ISSUE FOR DEVELOPMENT APPLICATION

Project: PROPOSED ADDITION & ALTERATIONS TO AN EXISTING RESIDENCE

Address: 19 CRANBROOK LANE, BELLEVUE HILL NSW 2023

Rev	Issue	Date	Description
A	23.06.08	REVISED PER LEC PROCEEDINGS

Drawing
SITE PLAN

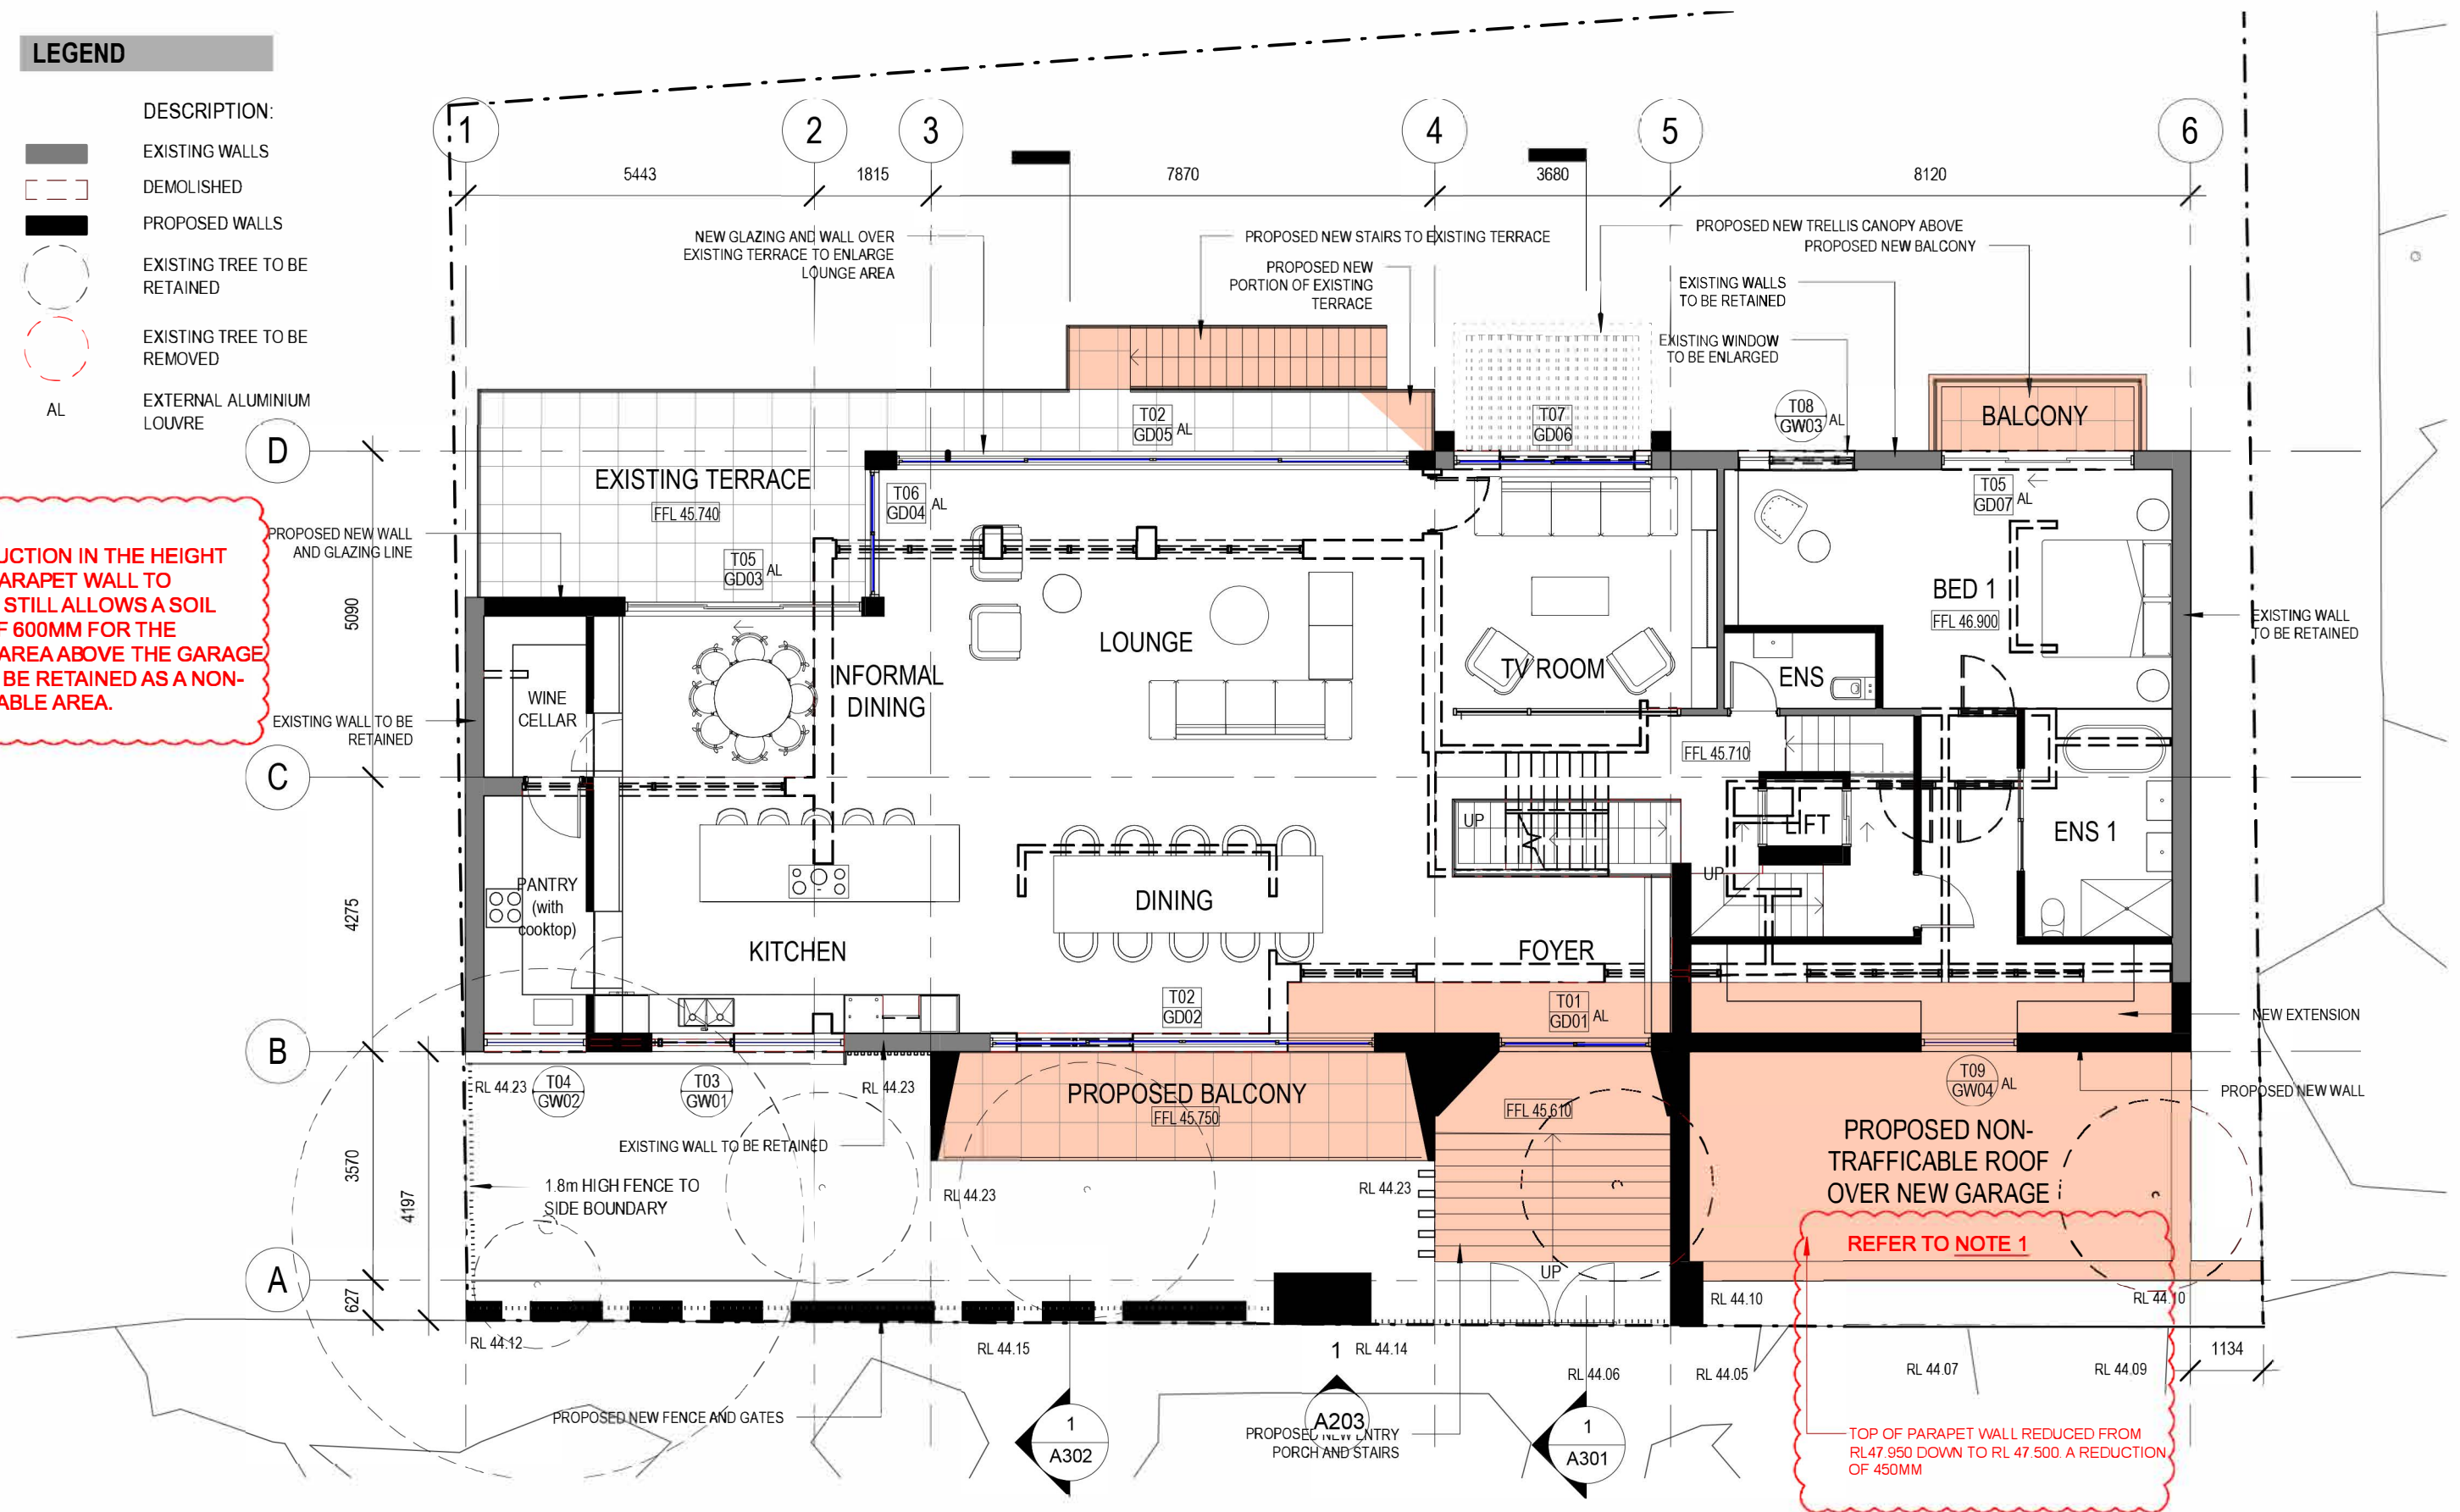
NOTE 2:
PROPOSED LOCATION OF TWO ADDITIONAL TREES TO BE PLANTED SHOWN IN RED AS PER THE RECOMMENDATION OF COUNCIL'S LANDSCAPE OFFICER.

THE ADDITIONAL TREES (2) ARE TO BE IN ACCORDANCE WITH COUNCIL'S RECOMMENDED TREE SPECIES.

NOTE 1:
THE REDUCTION IN THE HEIGHT OF THE PARAPET WALL TO RL 47.500 STILL ALLOWS A SOIL DEPTH OF 600MM FOR THE GARDEN AREA ABOVE THE GARAGE ROOF TO BE RETAINED AS A NON-TRAFFLEABLE AREA.

GROUND FLOOR

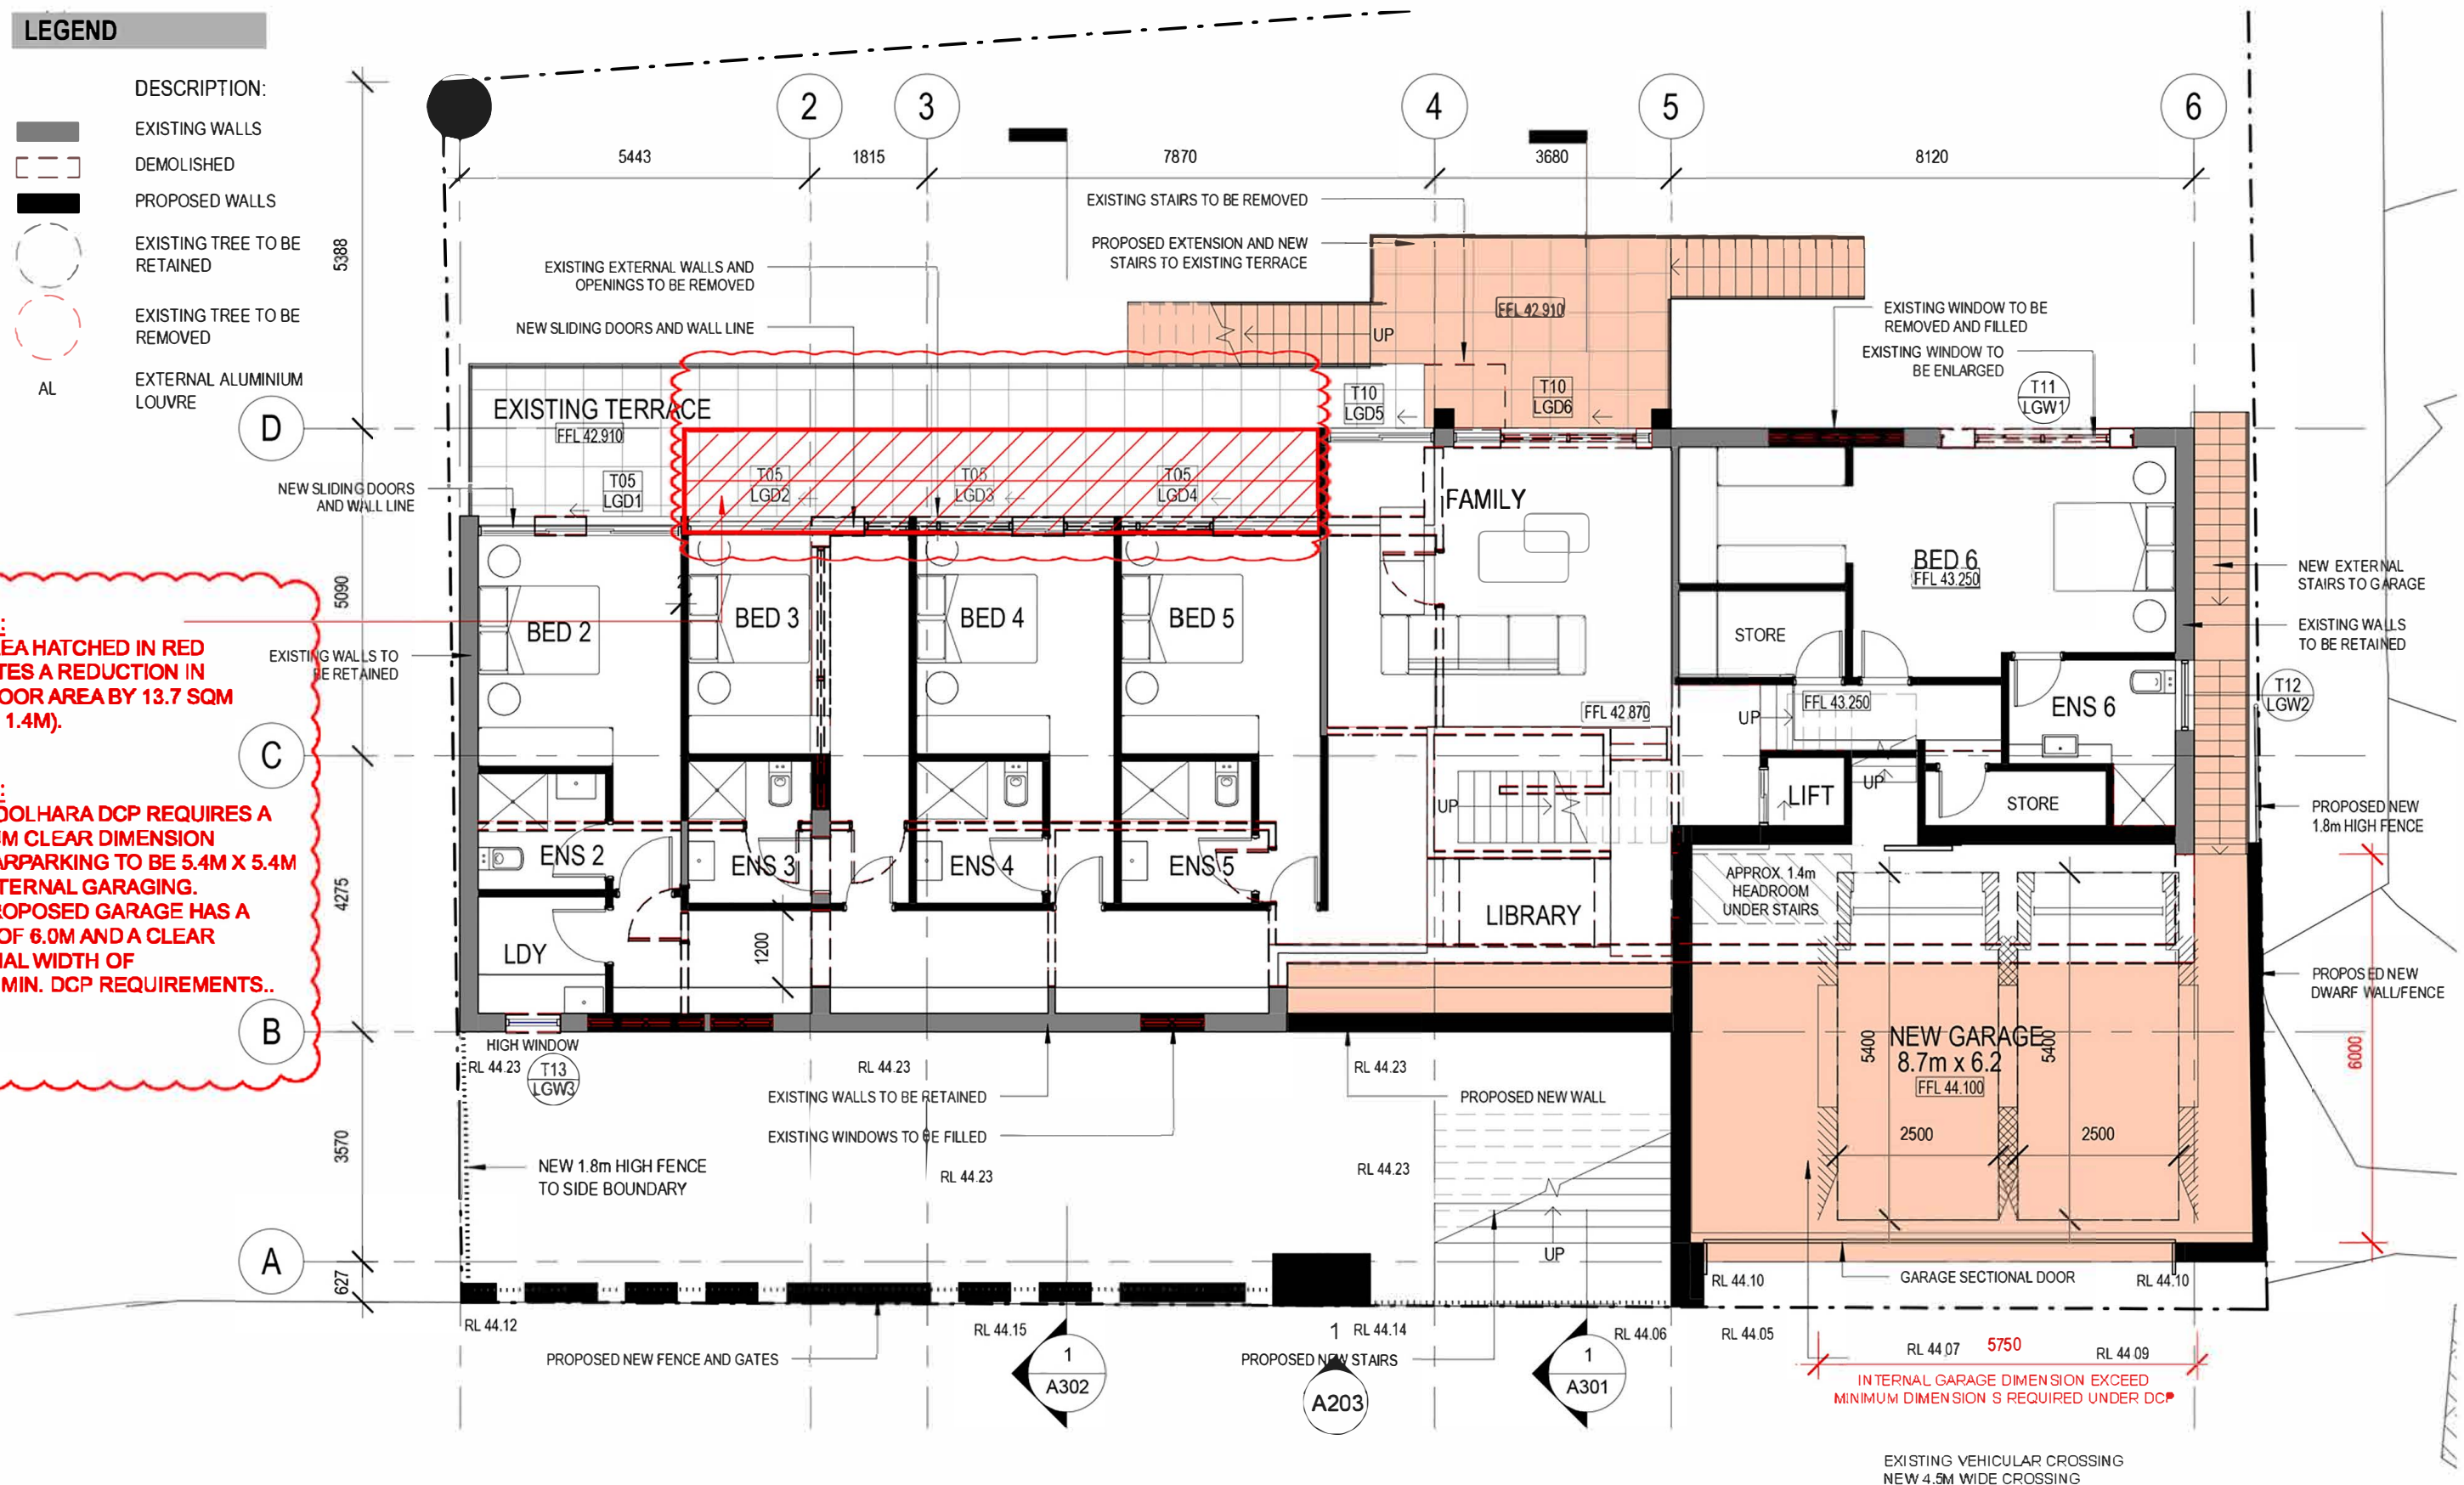
NOTE 1:
THE AREA HATCHED IN RED INDICATES A REDUCTION IN THE FLOOR AREA BY 13.7 SQM (9.8M X 1.4M).

NOTE 2:
THE WOOLHARA DCP REQUIRES A MINIMUM CLEAR DIMENSION FOR CARPARKING TO BE 5.4M X 5.4M FOR INTERNAL GARAGING. THE PROPOSED GARAGE HAS A DEPTH OF 6.0M AND A CLEAR INTERNAL WIDTH OF 5.750M MIN. DCP REQUIREMENTS..

Drawing
WEST ELEVATION

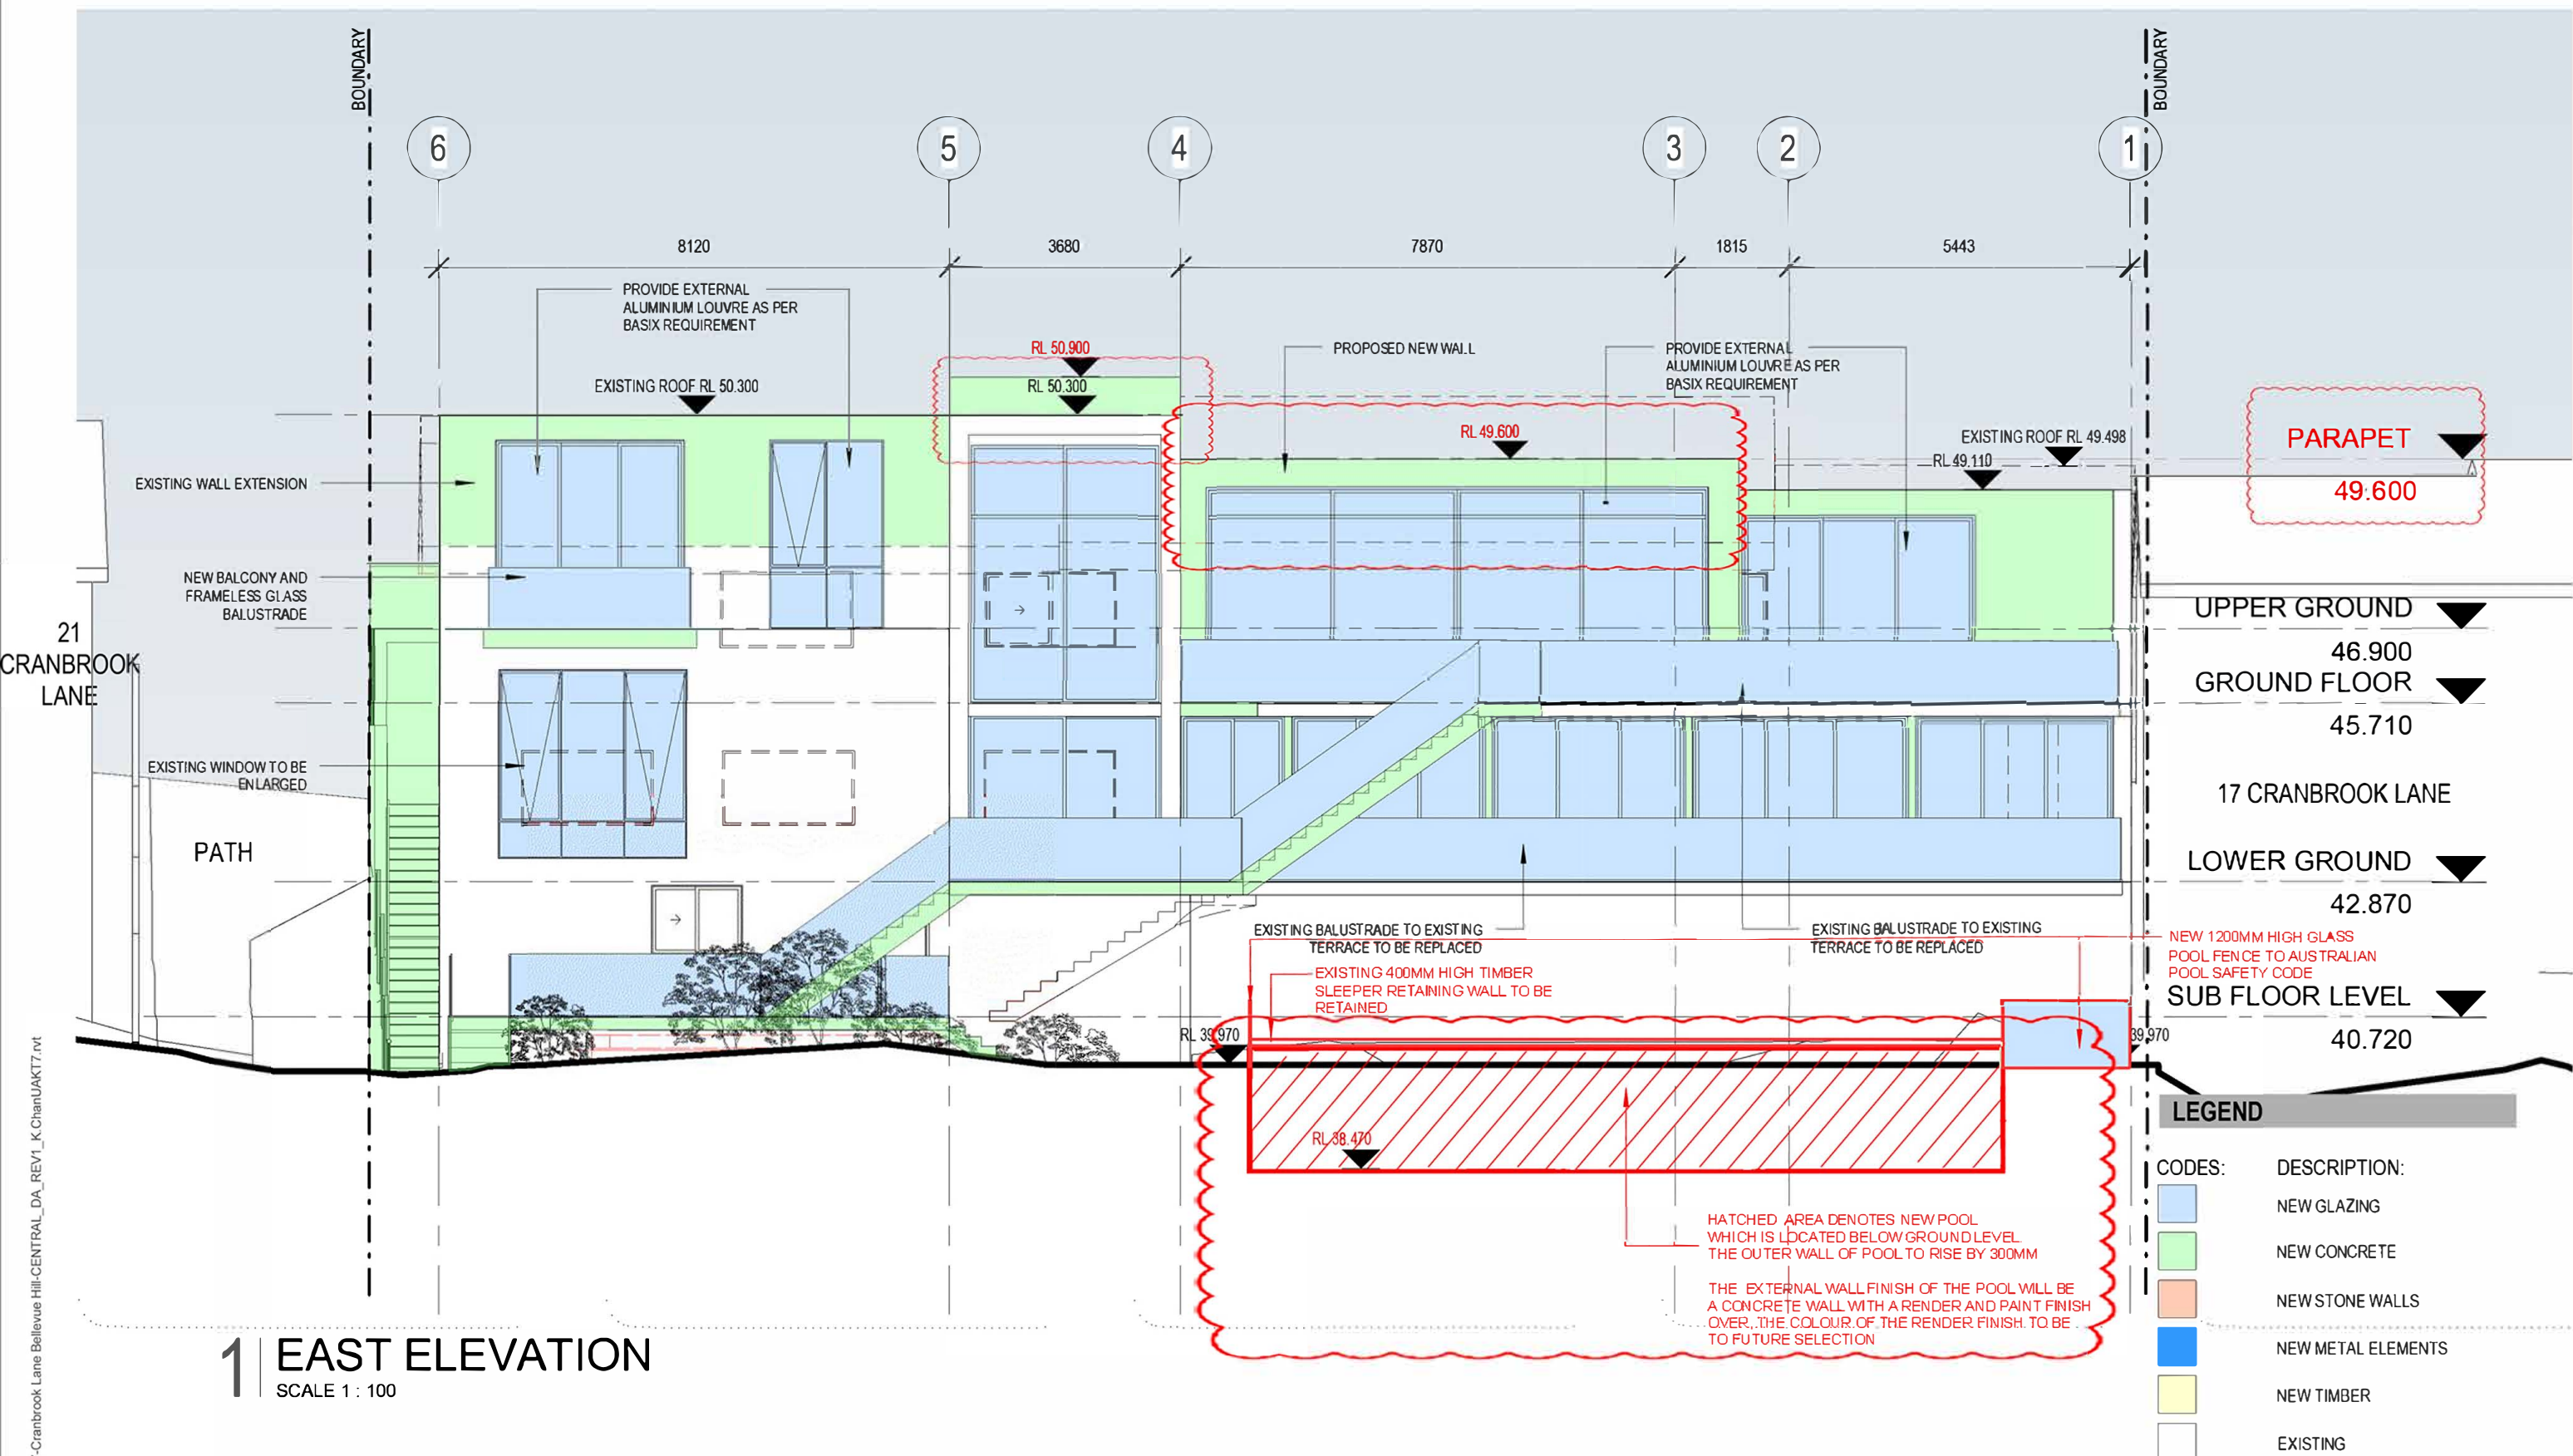
NOTE 2:
THE HEIGHT OF DWELLING FROM CRANBROOK LANE IS WELL UNDER THE MAXIMUM HEIGHT LIMIT.
